185th session

Proposal for Supplement 1 to the original version of UN Regulation No. 159 (Moving Off Information Systems)

Submitted by the Working Party on General Safety Provisions *

Figure 1
Set Up for Static Crossing Tests

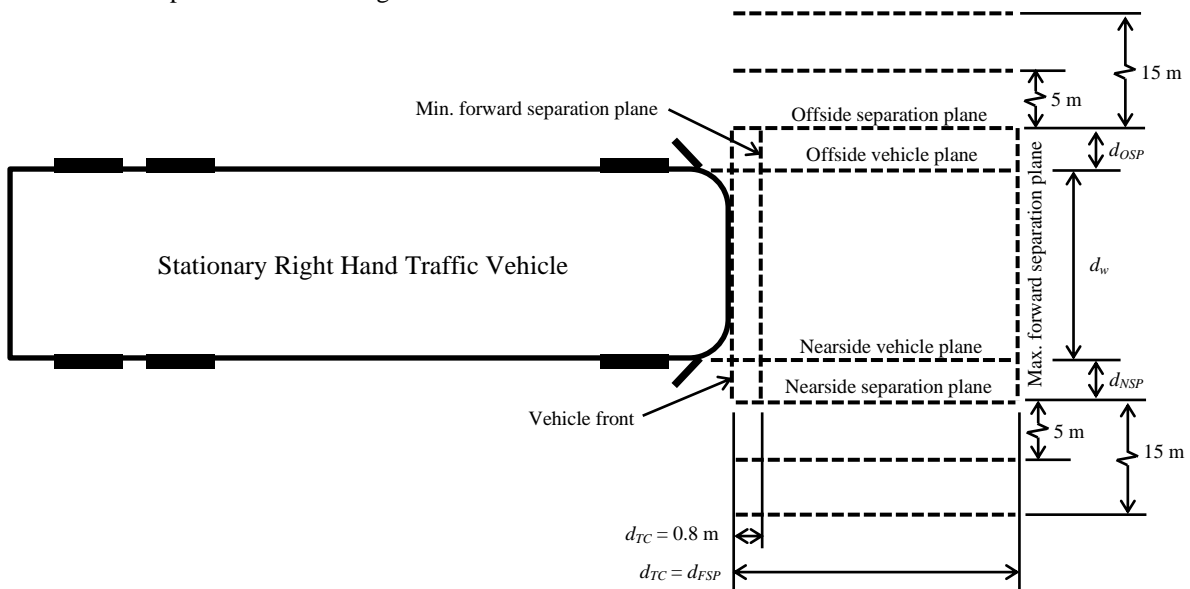
Appendix 1, amend to read:

Where the following definitions apply:

d_w vehicle width.

d_{NSP} the distance from the nearside vehicle plane to the nearside separation plane, defined as 0.5 m.

d_{OSP} the distance from the offside vehicle plane to the offside separation plane, defined as 0.5 m.

d_{TC} the forward separation distance for each test case.

d_{FSP} the distance from the vehicle front to the maximum forward separation plane.
